**CITY OF SEQUIM PLANNING COMMISSION STAFF REPORT**  
 HOME SUBDIVISION; DIVISION B PRELIMINARY MAJOR SUBDIVISION  
 PLANNING FILE SUB 19-001  
PUBLIC MEETING DATE: JANUARY 4, 2022

**FIGURE 3  
PRELIMINARY PLAT LAYOUT**

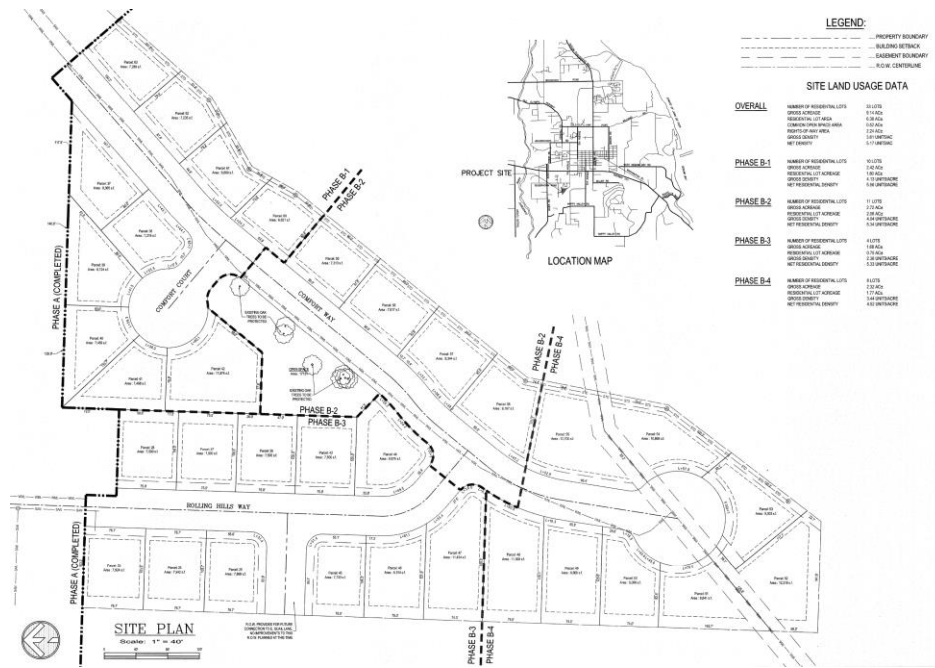
7. Relocate Driveways outside of Water Main Easement. Lots 52 and 54 show the driveway within the water main easement, relocate this driveway to outside of the WML easement.
8. Show the Highland Irrigation Ditch as required by RCW 58.17.310. The Highland Irrigation District will be contacted as part of the application review process to ensure that provision is made for irrigation right-of-way. Show the location of the existing irrigation (Highland Irrigation District) facilities, specifically at parcel 15, 52, 53 and 55. Provide documentation from Highland Irrigation District showing coordination and confirmation of the irrigation ditch being abandoned.

12. Show swale, grading for swale, and a cross section: please show the proposed property lines, grade, existing stormwater location, swale location and vehicular access corridor. The Legacy Homes Subdivision shows sheet flow and dedicated drainage paths over the "Landslide Hazard Area" and onto the proposed development. Specifically, Parcels 58-63, 52, 53, 15, 55 and Lots 32 and 33 are directly impacted by the storm water runoff from this slope. Applicant stated a swale will collect this runoff.
